**RE: Carlisle Marketplace
2100 Carlisle NE
Conceptual Grading Plan Stamp Date: none (7/19)
Drainage Report Stamp Date: none (7/19)
Hydrology File: H17D097**

Based on the submittal received on 7/23/19, the Conceptual Grading and Drainage Plan cannot be approved until the following corrections are made:

CONCEPTUAL
GRADING

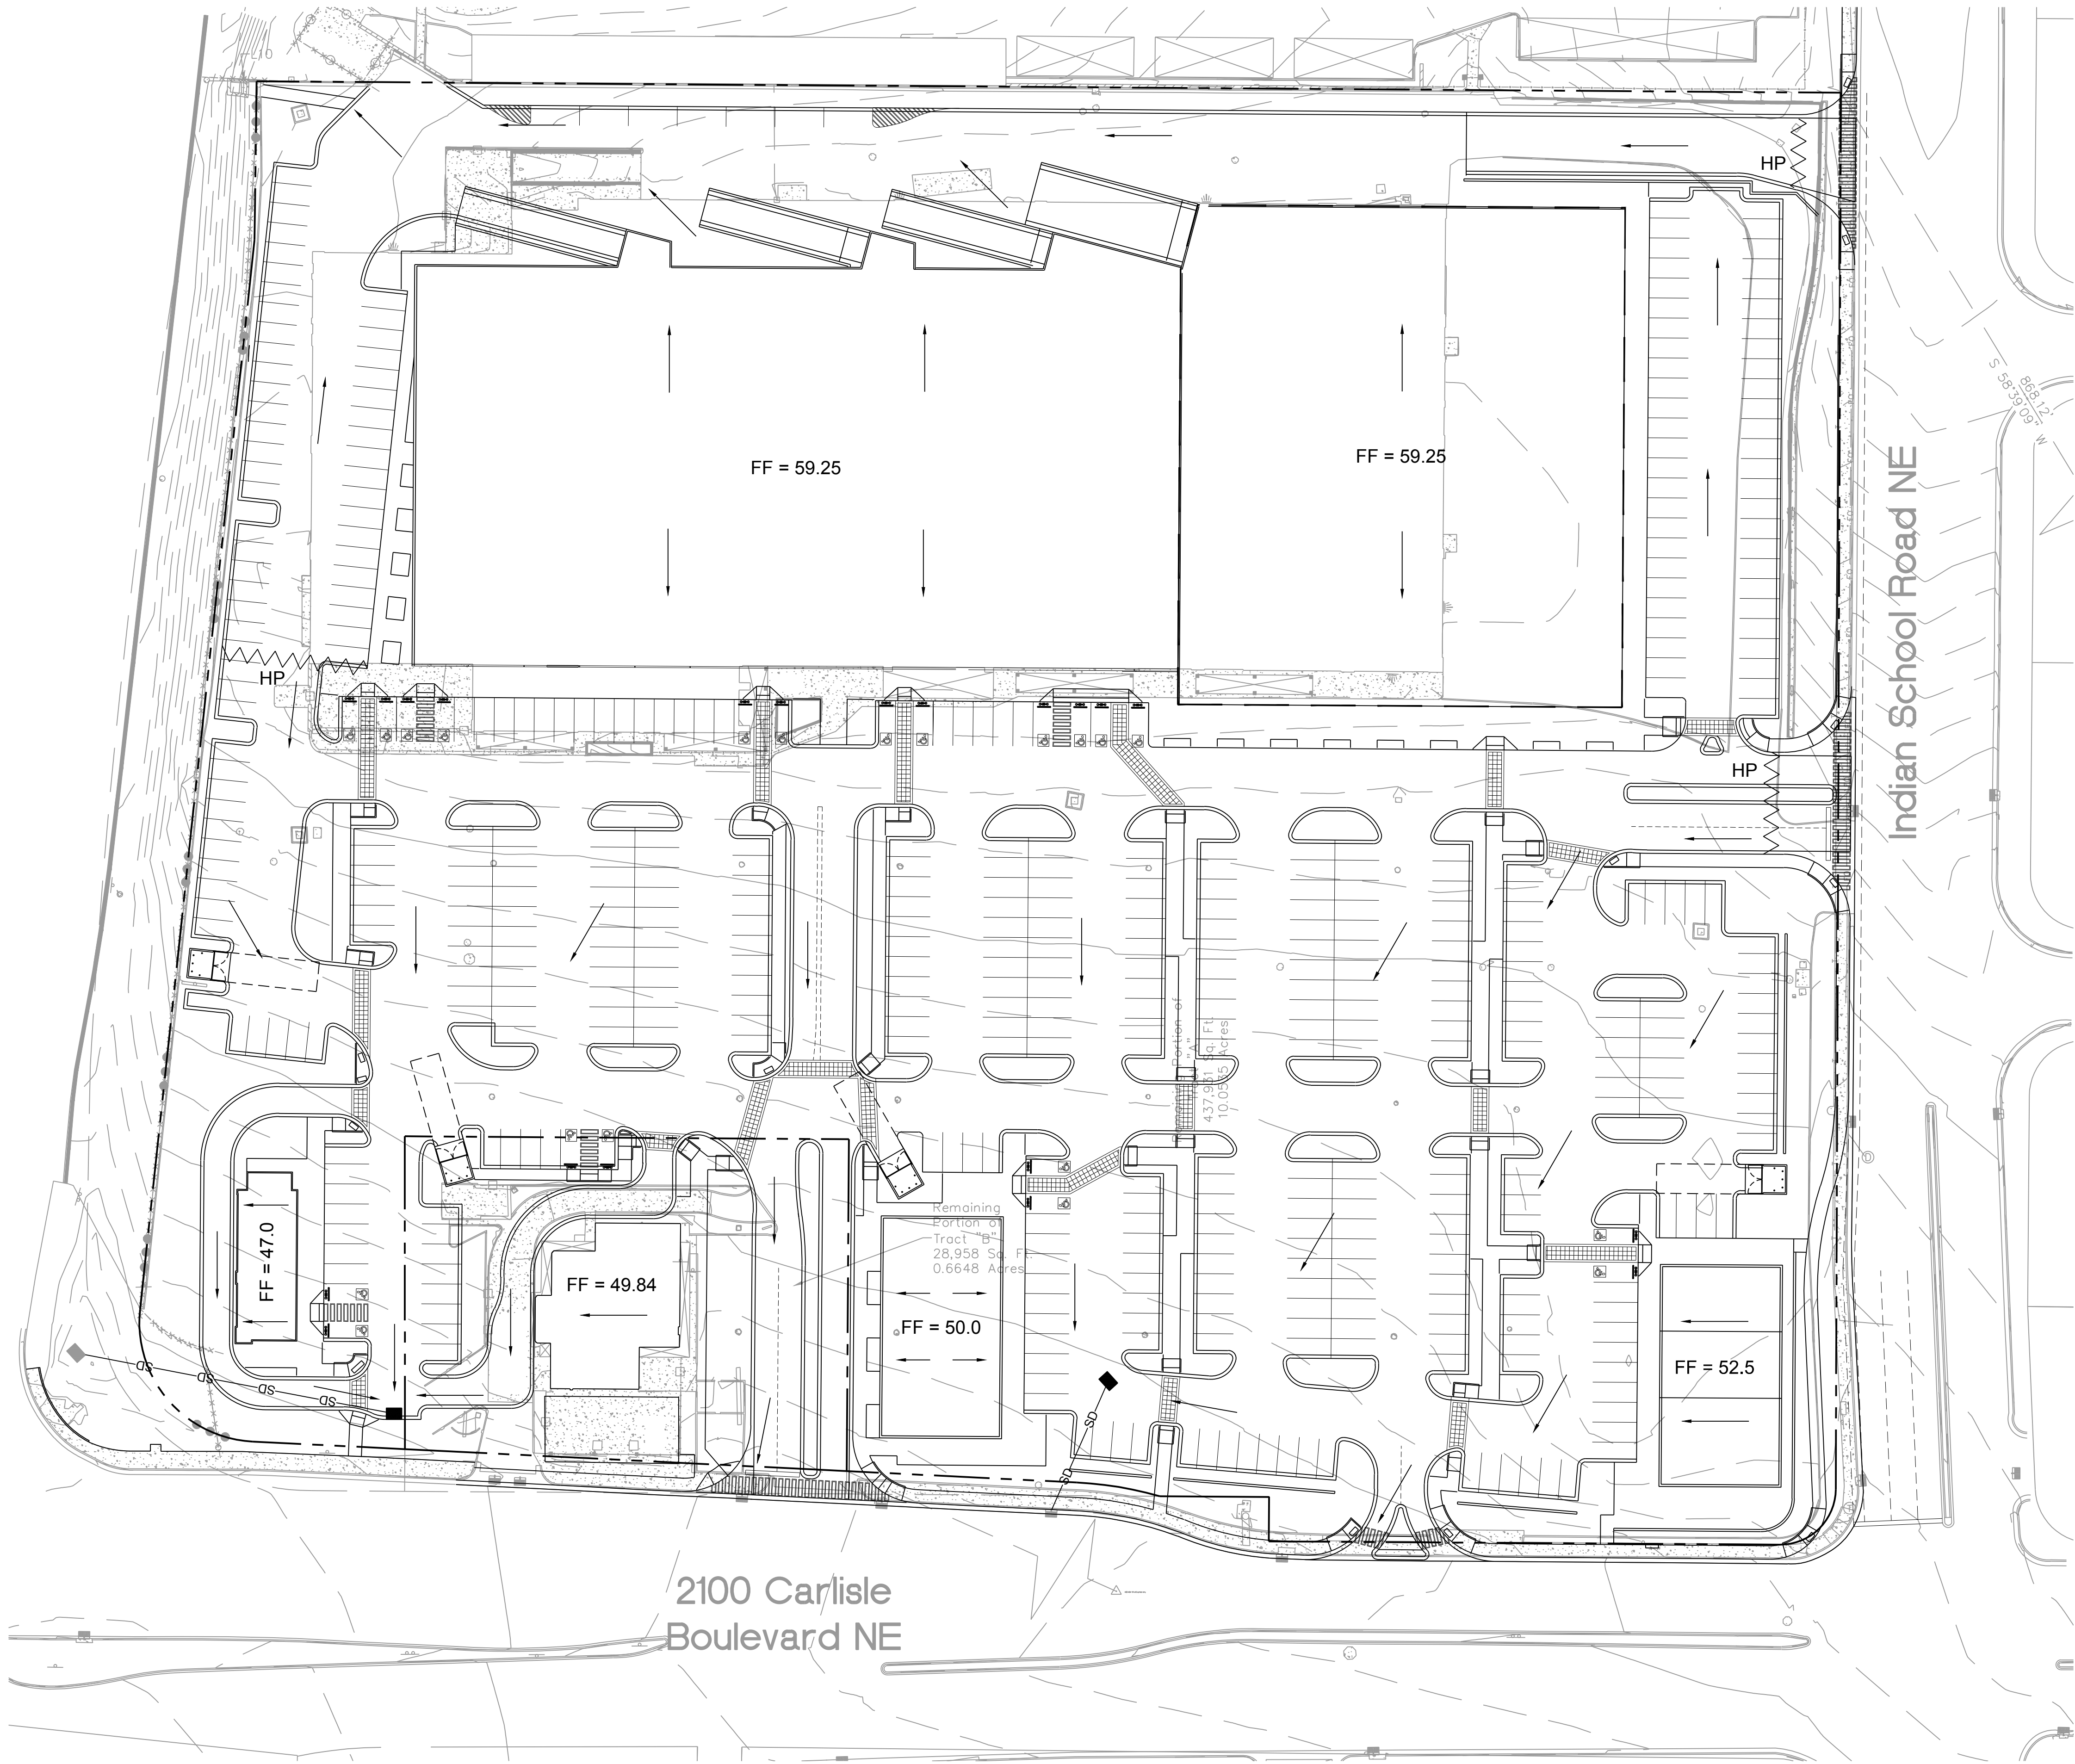
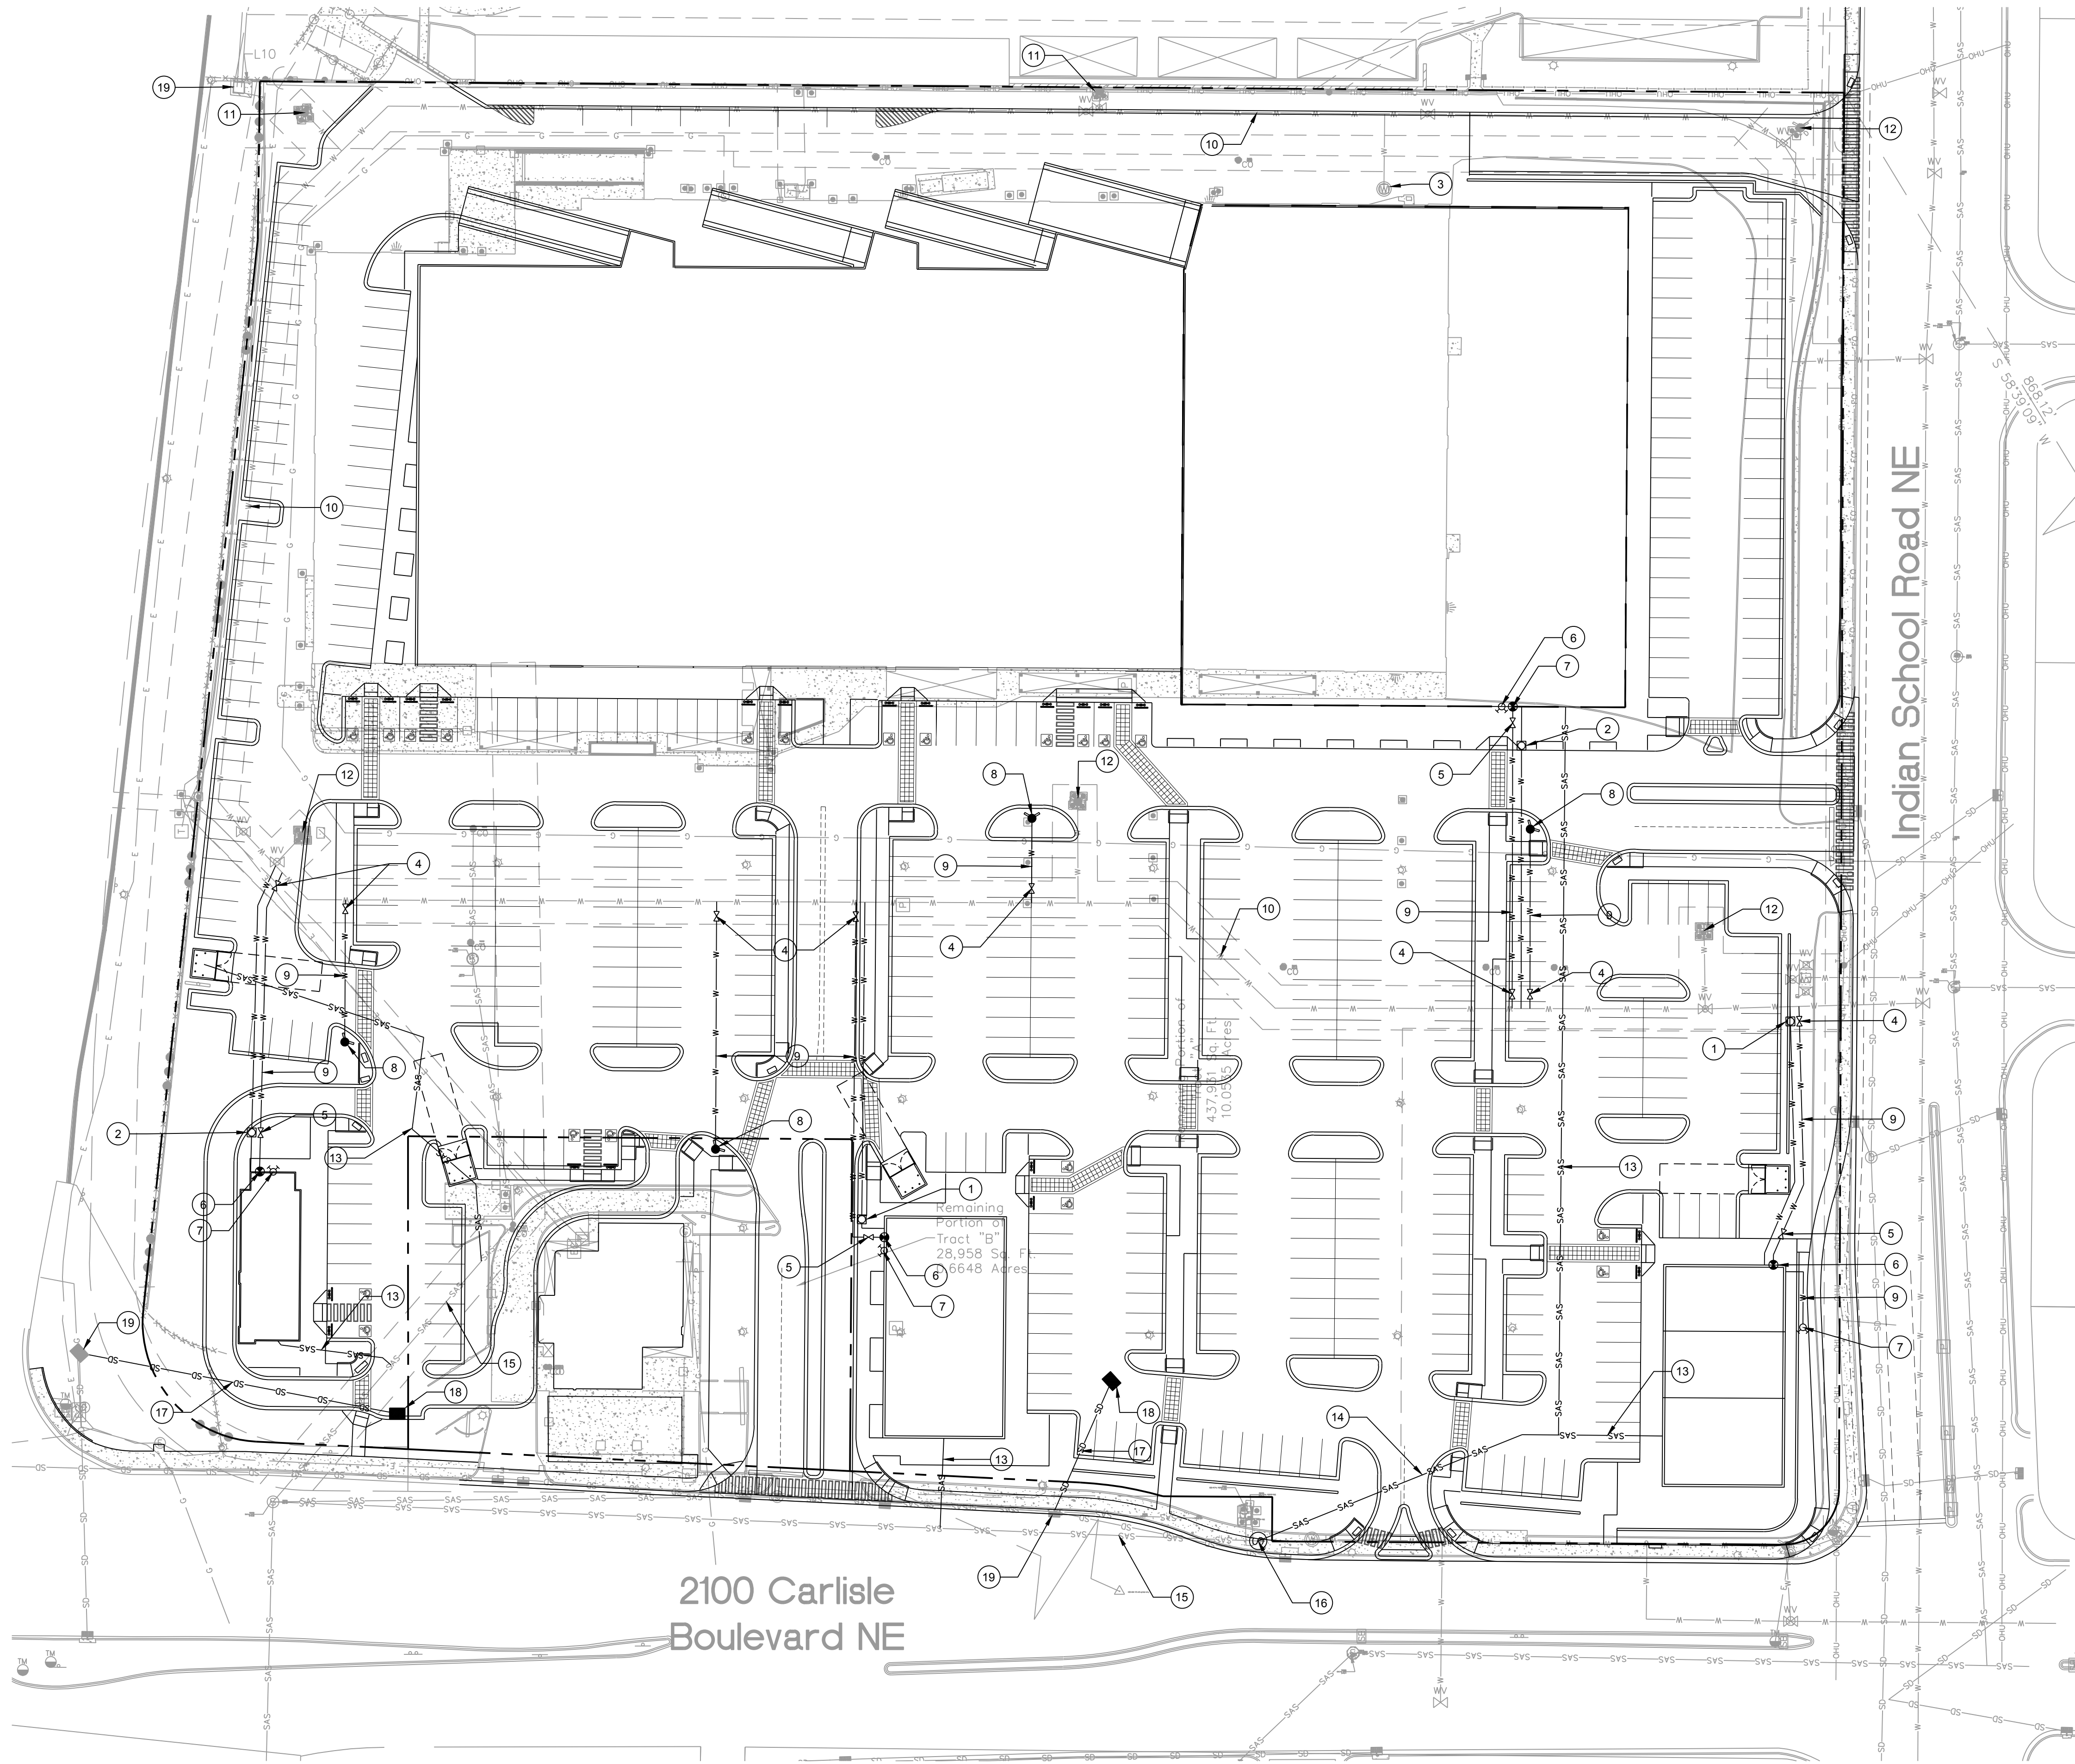
1. Please provide an engineer's stamp with a signature and date on the plan and use the [current DTIS version](#) (11/2018) when resubmitting.
2. Identify all existing drainage easements on the plan, as well as any proposed easements, vacations, and lot line adjustments.

3. Identify limits of grading, paving, and building construction. Identify what is to remain and what will be removed or replaced.
4. Include project benchmark and datum.

5. Show the grading and site work on the grading plan per the DPM Ch.22.7, *Grading Plan Checklist*.
6. Please provide the stormwater quality volume (SWQV) calculations for each basin draining to each pond. The stormwater quality ponds need to be sized for the areas draining to them.

7. Payment in Lieu of onsite management of the SWQV must be made prior to Building Permit, not C.O.
8. Please show and label the pond(s) and include a label on each with the SWQV and elevation, the 100-year volume and elevation, the peak 100 year inflow and outflow, the spillway crest elevation, and the spillway flow depth.
